**Response to
Request for Additional Information No. 227 (2564, 2598), Supplement 3
6/05/2009**

**U. S. EPR Standard Design Certification
AREVA NP Inc.
Docket No. 52-020
SRP Section: 19 - Probabilistic Risk Assessment and Severe Accident
Evaluation
Application Section: 19**

Question 19-298:

**Figure 19-298-1 Hydrogen Mass in Containment for Transient MAAP
Case Ca_4_1c_25_mixdmp with 25% of PAR Units Available**

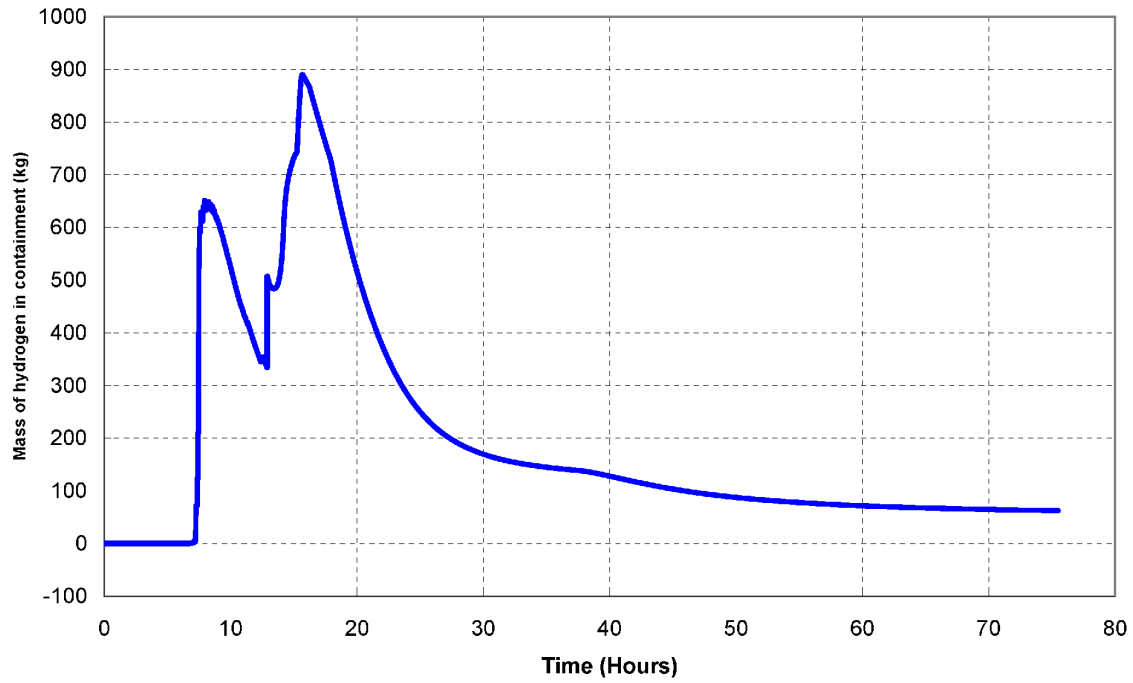
(Follow-up to Question 19-277) In response to Question 19-277, AREVA evaluated hydrogen deflagration loads in containment assuming 75 and 50 percent passive autocatalytic recombiner (PAR) availability. The staff also noted that AREVA also added an insight to FSAR Table 19.1-109 recommending PAR availability during shutdown. However, PAR availability is not required by technical specifications. Thus, the staff requests information concerning how many PAR units have to be out of service to reach the containment hydrogen mass of 940 kg which was used for deflagration load calculations in the shutdown Level 2 analysis.

MAAP runs with multiple fractions of the large PAR units disabled, showed that with 25 percent availability of the large PAR units (equivalent to 75 percent unavailability), the maximum hydrogen mass in containment is determined to be smaller than 940 kg. This is shown in Figures 19-298-1 and 19-298-2 for transient and LOCA scenarios, respectively. The hydrogen peak masses obtained with 25 percent of the large PAR units available are:

- A hydrogen peak of 891 kg for the transient scenario Ca_4_1c_25_ mixdmp.
- A hydrogen peak of 932 kg for the LOCA scenario Ca_4_3_25_ mixdmp.

It can be concluded from these results that the analysis of hydrogen phenomena in containment, developed in the shutdown Level 2 PRA, is applicable for a range of availability between 25 percent and 100 percent of the large PAR units. As stated in the response to RAI 197, Question 19-277, provided that multiple PAR units are installed at
